New Reactors Division – Generic Design Assessment
Step 4 Assessment of Electrical Engineering for the UK HPR1000 Reactor

Assessment Report ONR-NR-AR-21-011
Revision 0
January 2022

Electrical Power System Single Line Diagram

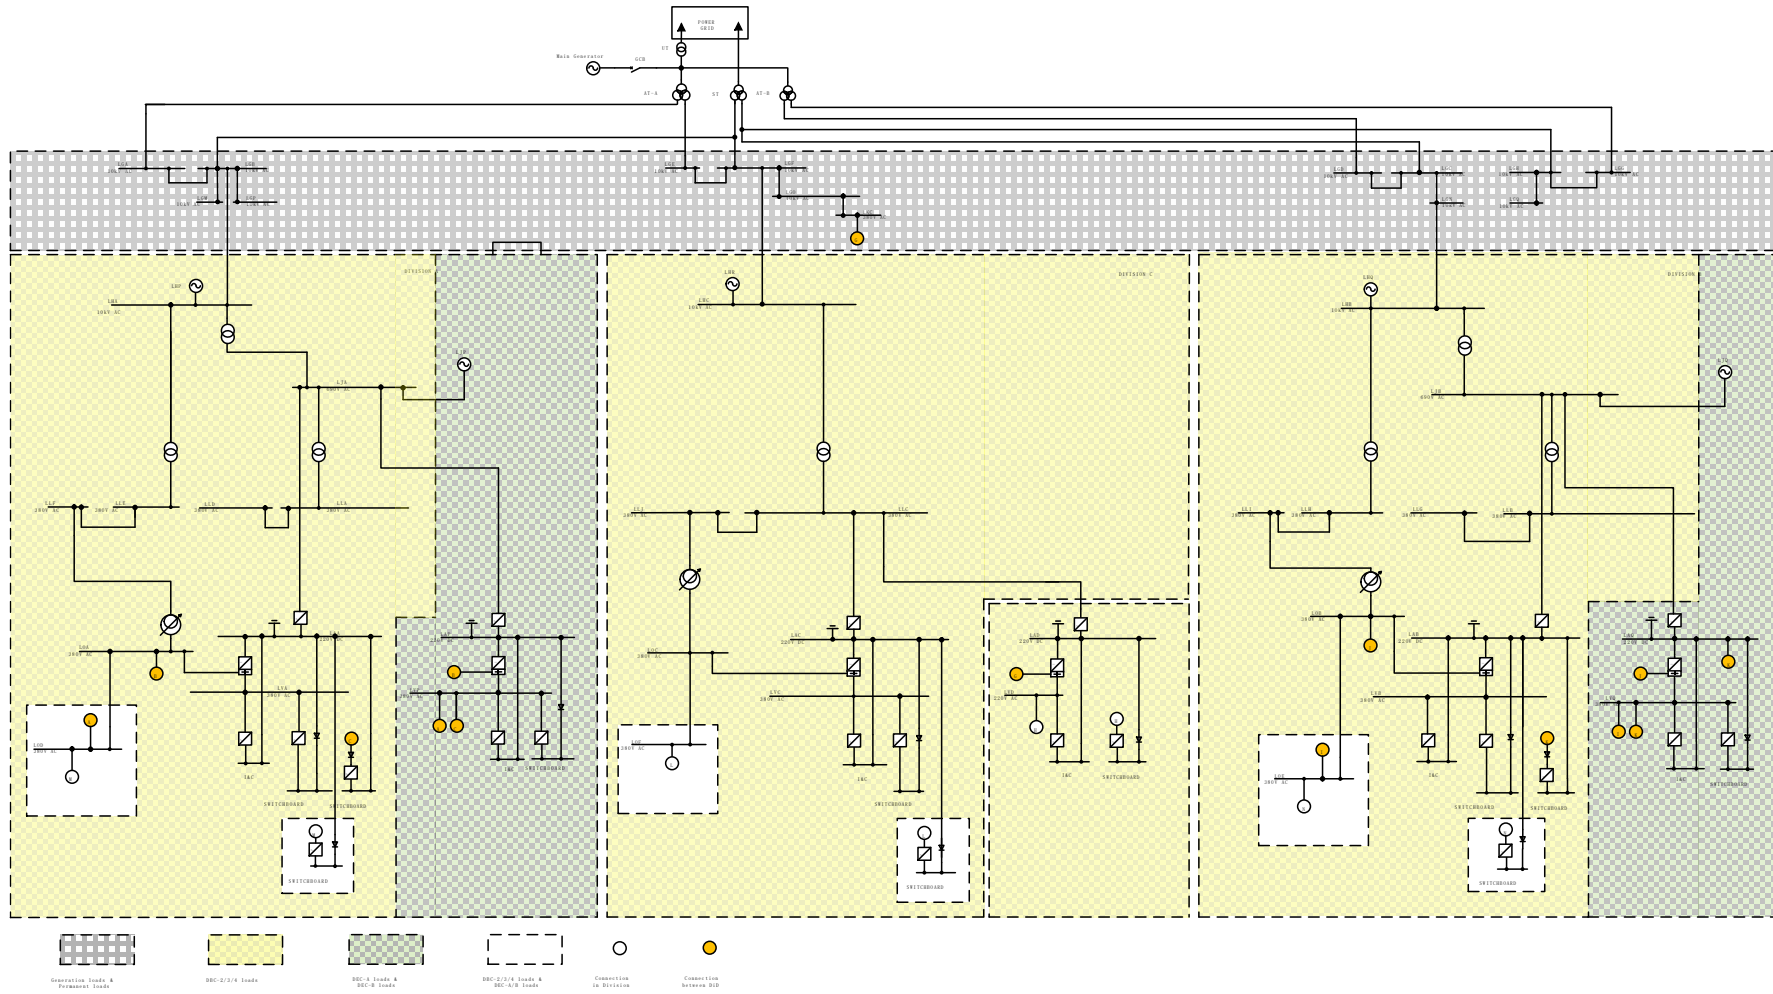
70. An overview of the UK HPR1000 electrical power system (EPS) is shown in Figure 1 and a high-level description of the sub-systems and their roles is set out in the PCSR and Basis of Safety Case. The EPS consists of the following sub-systems:

Electrical Power System Low Voltage Switchboard Diverse Design Scheme

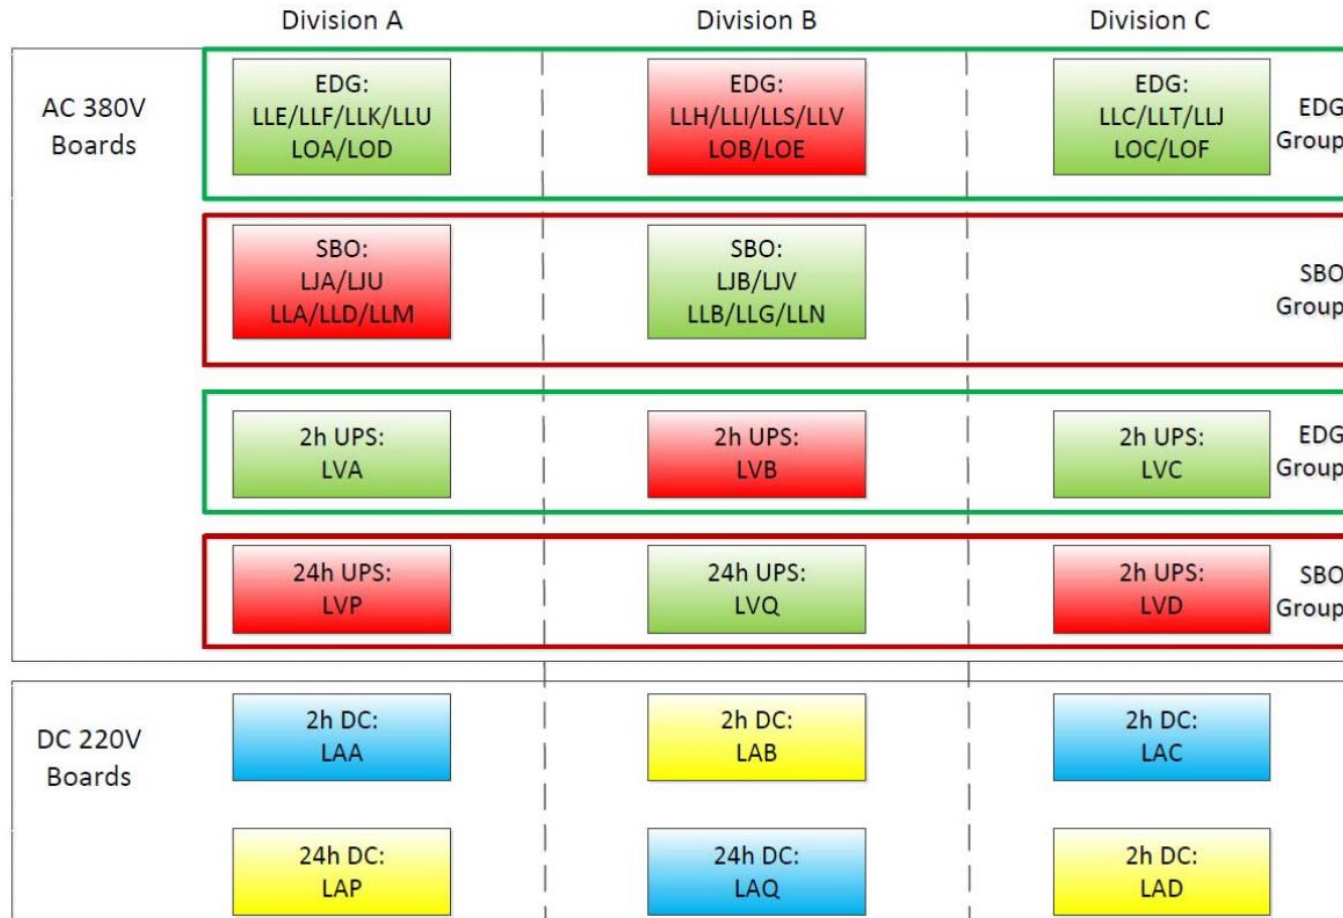
190. The RP has introduced a requirement for two diversity groupings to be applied to the LV AC electrical system as well as the NI 2 hour and 24 hour UPS. This work not only supports its assessment of the inherent CCF risk to the electrical system but also supports its work in response to RO-UKHPR1000-0023. The proposed groupings are set out in Figure 2. I consider the analysis undertaken by the RP and the decision to introduce these groupings to be well set out. The RP has appropriately balanced the benefit from diversity against the increased complexity, taking into account sensitivity studies, to ensure that its choice of diversity is balanced.
